Form 3160-5
(June 2019)

SUNDRY NOTICES AND REPORTS ON WELLS
Do not use this form for proposals to drill or to re-enter an abandoned well. Use Form 3160-3 (APD) for such proposals.

Betty 5 Fed Com 302H (FKA Getty 5 Fed Com 756H) API #: 30-025-52103

EOG respectfully requests an amendment to our approved APD for this well to reflect the following changes:

WELL LOCATION AND ACREAGE DEDICATION PLAT

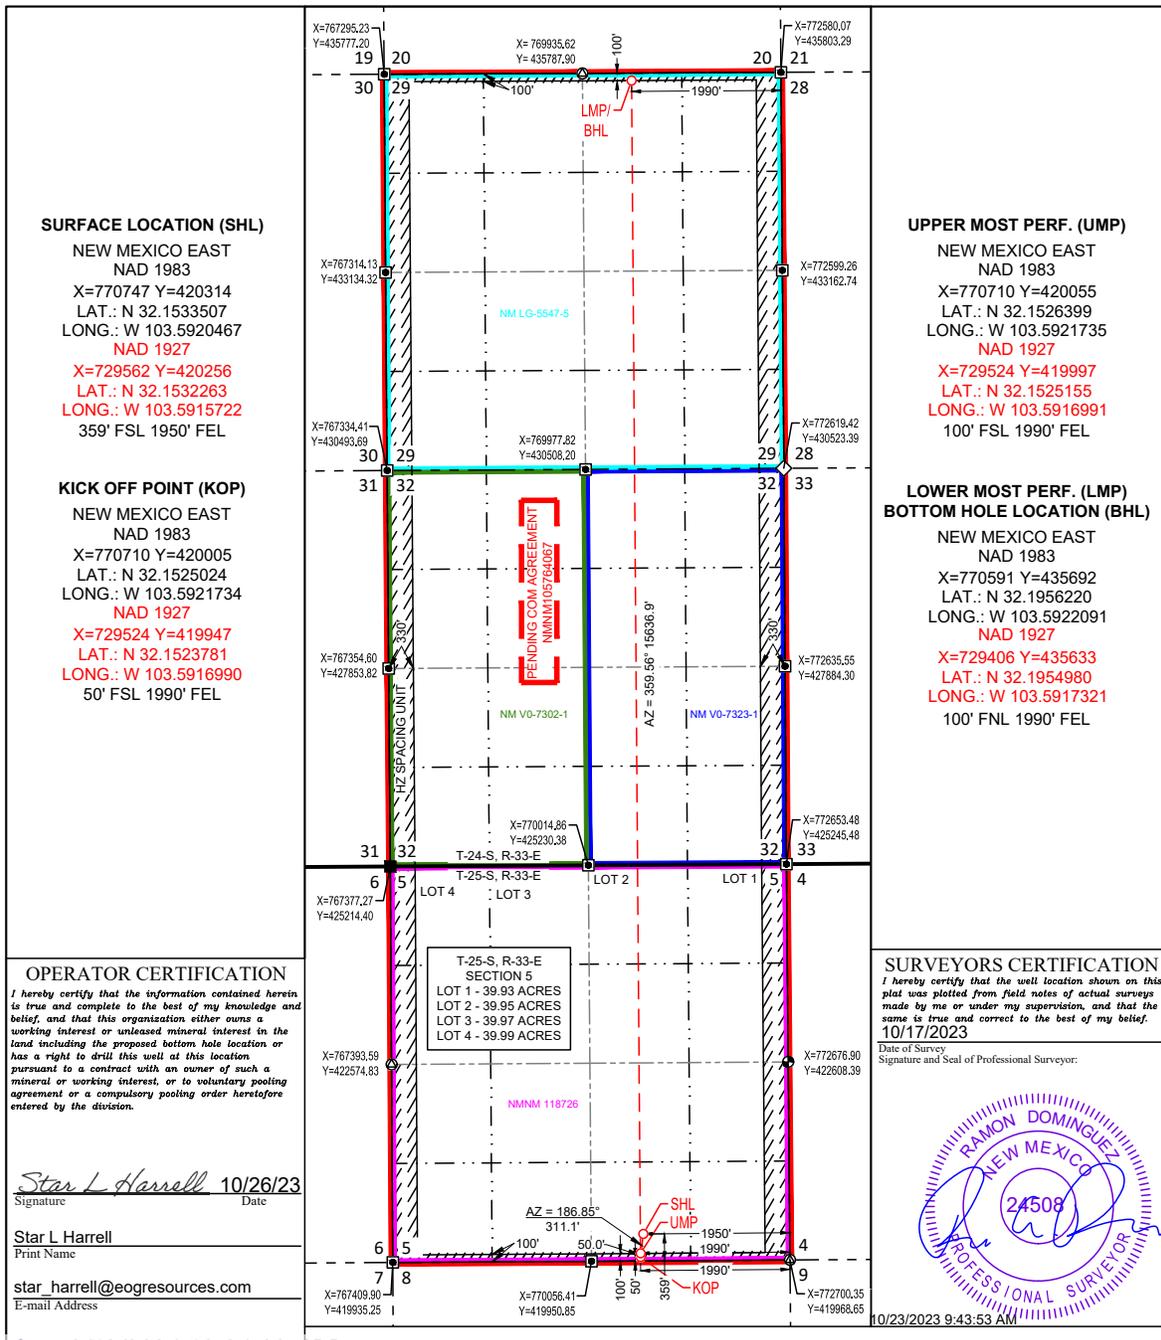
Change name from Getty 5 Fed Com 756H to Betty 5 Fed Com 302H.

Change SHL from T-24-S, R-33-E, Sec 5, 1313' FSL, 1578' FWL, Lea Co., NM, to T-25-S, R-33-E, Sec 5, 359' FSL, 1950' FEL, Lea Co., N.M.

Change BHL from T-24-S, R-33-E, Sec 32, 2539' FSL, 1101' FWL, Lea Co., NM, to T-24-S, R-33-E, Sec 29, 100' FNL, 1990' FEL, Lea Co., N.M.

Design A

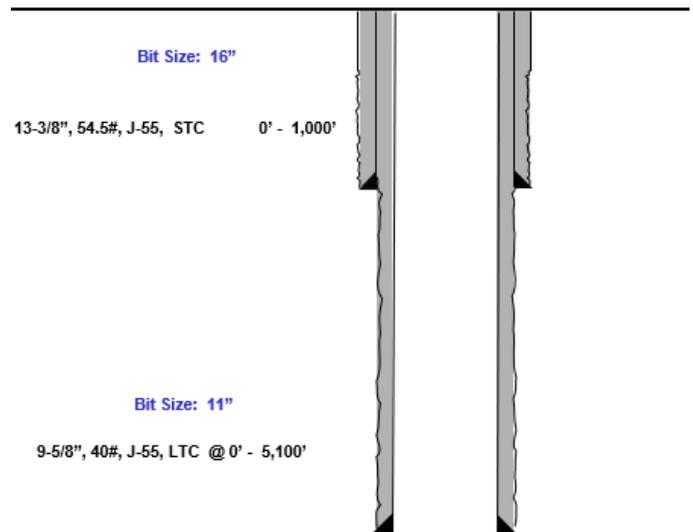
Annular Clearance Variance Request

EOG request permission to allow deviation from the 0.422" annulus clearance requirement for the intermediate (salt) section from Onshore Order #2 under the following conditions:

Proposed 11" Hole with 9.625" 40# J55/HCK55 LTC Casing

- 11" Bit + 0.52" Average hole enlargement = 11.52" Hole Size
 - 0.9475" Clearance to casing OD

Design B

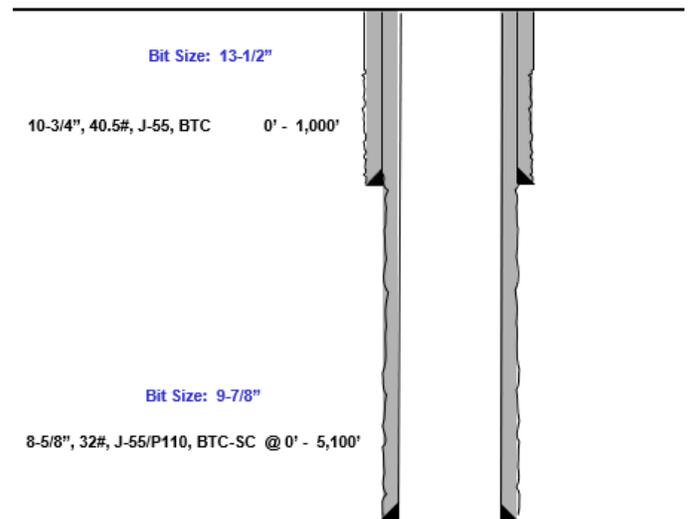
Proposed 9.875" Hole with 8.625" 32# J55/P110 BTC-SC Casing

- 9.875" Bit + 0.42" Average hole enlargement = 10.295" Hole Size
 - 0.835" Clearance to casing OD

$$= \frac{10.295 - 9.125}{2}$$
- Previous Shoe – 10.75" 40.5# J55 STC
 - 0.4625" Clearance to coupling OD (~1,200' overlap)
